July 25, 1990
LD-90-051

Subject: UNC-2901 Shipping Container Application
Discrepancy

COMBUSTION ENGINEERING, INC.
CERTIFICATE OF COMPLIANCE NO. 6294
UNC-2901 SHIPPING CONTAINER
EVALUATION OF APPLICATION DISCREPANCY

UNC-2901 SHIPPING CONTAINER
 CERTIFICATE OF COMPLIANCE NO. 6294
 AMENDMENT REQUEST

PICTURE 3 -Condition of outer drum after 30' drop test (Test #1).

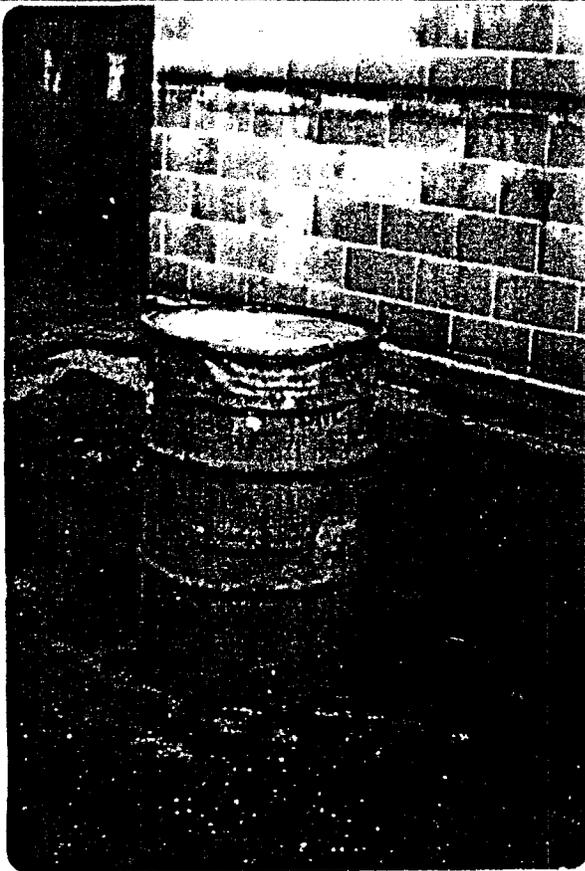
to use a square insert for the purpose of testing. Item 4 (Attachment 4) is a copy of page 2-12 from the currently approved Certificate of Compliance application for the UNC-2901 shipping container. The subject page is one of several in the application which document the container testing and which clearly show the UNC-2900 designation stenciled on the tested container. The photograph also clearly shows only two (2) rolling hoops on the tested container. From this information, two conclusions can be drawn. First, the container is obviously not a DOT 17H drum which would have had three (3) rolling hoops. Secondly, it is clear that it was the same UNC-2900 non-DOT 17H type drum approved by the Nuclear Regulatory Commission for UNC-2900 shipping containers that underwent testing. From all this it can be concluded that the non-DOT 17H drums used for the fabrication of shipping containers meet Nuclear Regulatory Commission requirements and are acceptable for use.

AMENDMENT DATE:
JULY 25, 1990.
REV. 1
PAGE 1-3

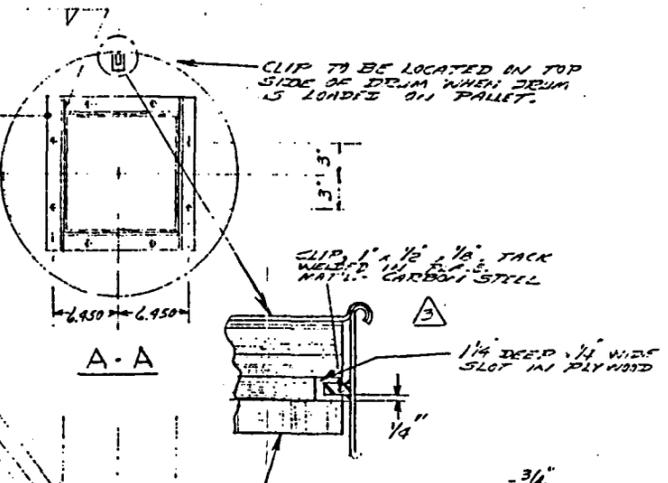
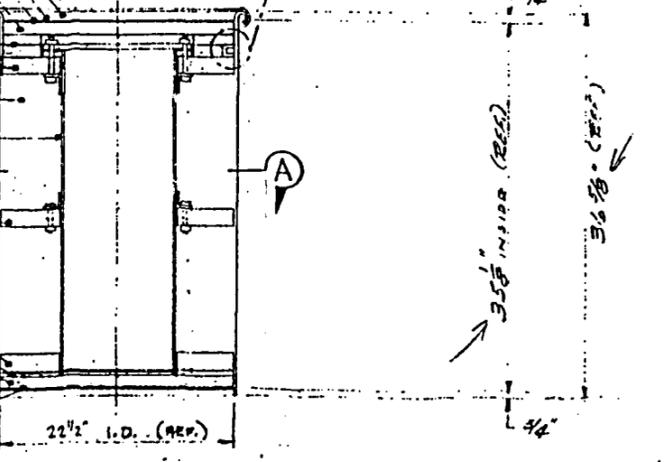
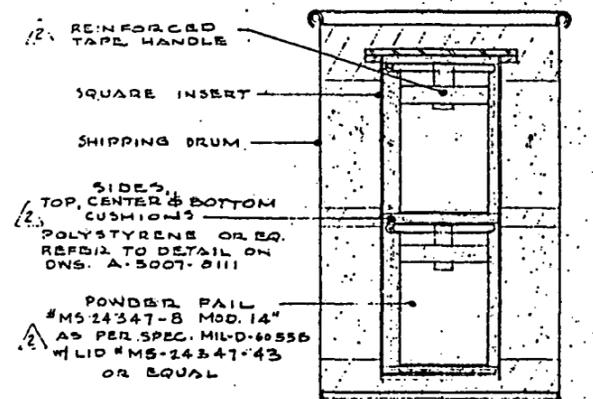
Further, the reference to a 12 gauge lid in Drawing No. NFM-D-4540 will be removed and replaced by the following statement:

16 gauge with at least one corrugation.

- ITEM DETAIL NO.
- 1 DRUM LID - 1/2" GAGE STEEL WITH AT LEAST ONE CORRUGATION
 - (A) ALUMINUM COVER .032 THK.
 - (B) ASBESTOS OR CERAMIC SHEET 1/8" THK X 22" DIA.
 - (C) PLYWOOD 1 1/2" THK. 2 @ 5/8"
 - CLAMP RING 12 GA. W/ 5/16 DIA BOLT
 - 2 ABOVE ITEMS (A), (B) AND (C) ARE LAMINATED TOGETHER TO FORM ONE UNIT AS SHOWN ON DWG. B-5007-8112

- 2A PLYWOOD 2 PLY. 1" THK.
- 3 HARDBOARD 1 1/2" THK. THERMAL INSULATION 6.75" @ 15"
- 4 SQUARE INSERT
- 5 HARDBOARD 1/2" THK.
- 6 DRUM - 57 GALLONS, 18 GALL BODY AND BOTTOM. SIDE SEAMS RESISTANCE WELDED
- 7 HARDBOARD 1 1/2" THK.
- 2B PLYWOOD 1/2" THK.
- 1 PLYWOOD 1" THK. - 2 @ 1/2"

REV.	DATE	REVISION	BY	DATE
6	7/1/90	DRUM SPEC'S REVISED TO MATCH ORIGINAL CURRENT DRUM CONST.	ER	1/20/90
5	4/2/89	INSERT ITEM 4 AT ASSEMBLY NUTS WAS 2BY COMBUSTION ENGIN.	ER	1/20/89
4	7/1/87	1/8" THICK ASBESTOS OR CERAMIC WAS ASBESTOS		
3	9/23/71	CLIP 1 1/2" x 1/8" x 1/8" ADDED	ER	1/20/71
2	11-25-70	CHR. PLS. HOLE SIZE, ARROD HOLES ON CUSHION S & TOP PLYWOOD INSERT	VAL	1/20/70
1	5-17-70	REDRAWN	VAL	1/20/70

FIGURE 6.1
KENO MODEL FOR UNC-2901 SHIPPING CONTAINER

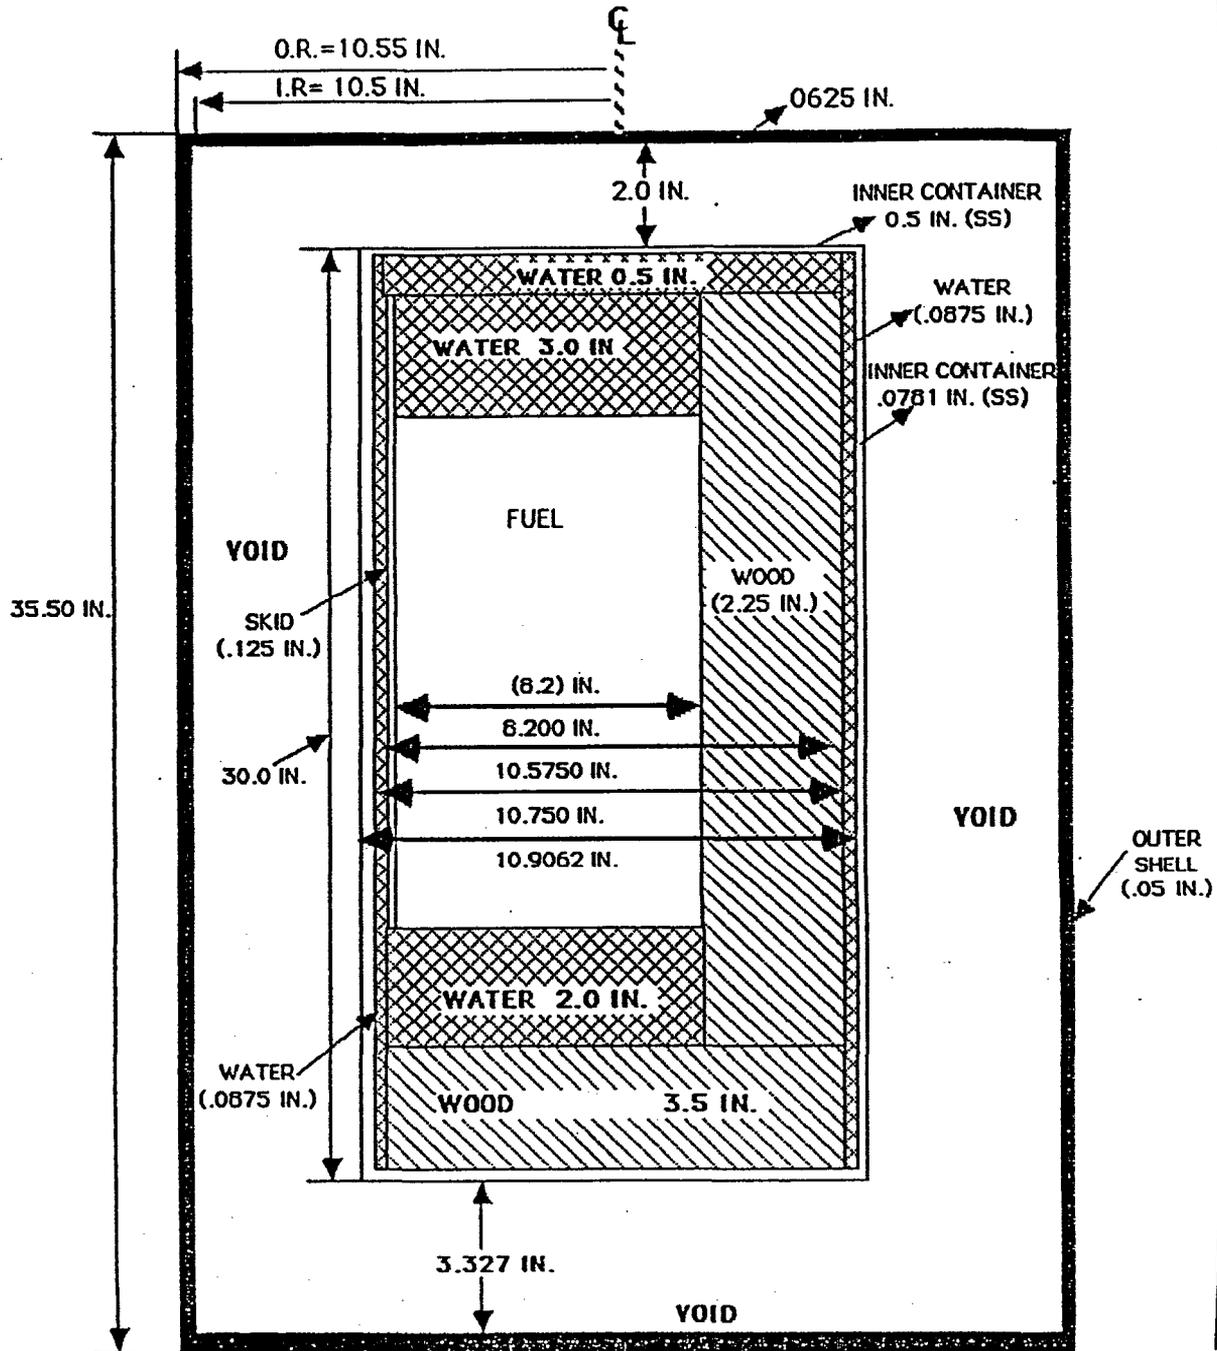
<u>Page No.</u>	<u>Description of Change</u>
1-1	Deleted reference to DOT 17H drum designation in Section 1.2.1. Replaced with cross reference to engineering drawing.
1-2	Provides updated revision numbers for engineering drawings D-5007-8086 and NFM-D-4540.
1-3	Provides revised drawing D-5007-8086, Rev. 6. New drawing deletes reference to DOT 17H drum designation and replaces with new fabrication information.
1-7	Provides revised drawing NFM-D-4540, Rev. 1. New drawing deletes reference to DOT 17H drum designation and 12 gauge lid specification and replaces with new fabrication information.
4-1	Deleted reference to specific revision number for drawing D-5007-8086, in Section 4.1.4.
6-3	Revised writeup for Section 6.3 regarding KENO-IV model for criticality calculations.
6-3a	New page. Overflow from page 6-3.
6-16	Added axial dimensions to KENO-IV model schematic.

The KENO-IV model for the UNC-2901 shipping container is shown in Figure 6.1. The overall height of the shipping container outer shell used in the model was 35.5 inches which is less than the overall height, 36.625 inches (see Drawing D-5007-8086, Rev. 6). The smaller overall height (and consequently smaller volume) as compared to the actual outer shell dimension is conservative for the purpose of assessing criticality safety.
